EXTRAPOLATION FOR OVC-HEVS

4.5.1. Interpolation range for NOVC- HEVs and OVC-HEVs

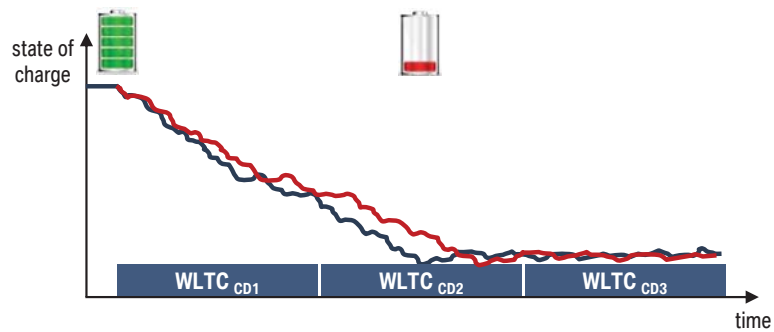
- Paragraph is valid for NOVC- as well as for OVC-HEV → Limit for the extrapolation is defined
- In case of OVC-HEVs the extrapolation is in parallel always linked to a charge-depleting test too due to the difference in cycle energy demand

- To avoid mistakes by the extrapolation of the charge depleting test, two criteria have to be checked in advance:
 - i. Make sure that in case of an extrapolation of an individual vehicle below vehicle low the amount of charge-depleting cycles of the individual vehicle does not change compared to vehicle low

- ii. Make sure that in case of an extrapolation of an individual vehicle above vehicle high the amount of charge-depleting cycles of the individual vehicle does not change compared to vehicle high

- iii. Make sure that in case of an extrapolation of an individual vehicle above vehicle high and in case that vehicle high was able to drive CD pure electrically until SOC_{min} is reached the individual vehicle is also able due to higher demand to electric power

- iv. Make sure that in case of an extrapolation of an individual vehicle below vehicle low and in case that vehicle low was not able to drive CD pure electrically until SOC_{min} is reached the individual vehicle is also not able due to lower demand to electric power

If the extrapolation is applied to OVC-HEVs and in the unlikely case that trigger for ICE start differs or the number of the transient cycle changes the manufacturer shall check:

- i) if the criterion in paragraph 4.5.7.1. of this Appendix applied to the individual vehicle with the lowest and/or the individual vehicle with the highest cycle energy demand is still fulfilled and
- ii) that the amount of charge-depleting cycles from the beginning of the test up to and including the transition cycle are identical comparing the individual vehicle with the lowest cycle energy demand with vehicle low and/or comparing the individual vehicle with highest cycle energy with vehicle high

Break-off criteria within the same CD cycle

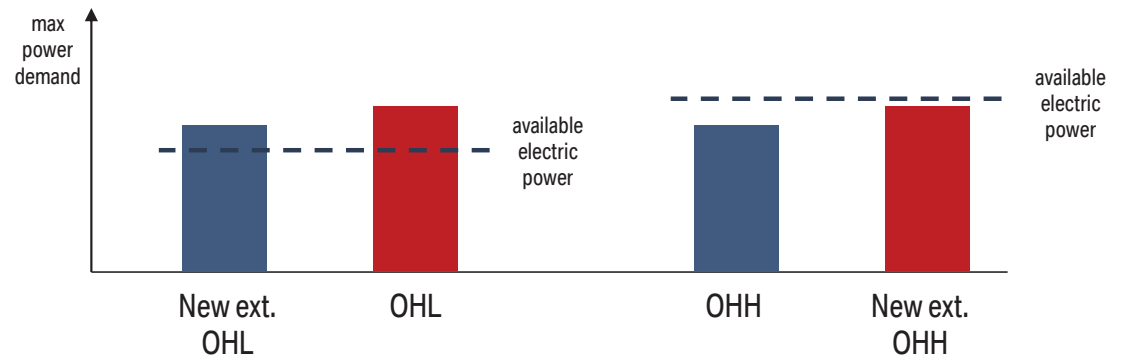
New ext. OHL still has to be not able to drive pure electrically in terms of electric power

New OHH still has to be able to drive pure electrically in terms of electric power
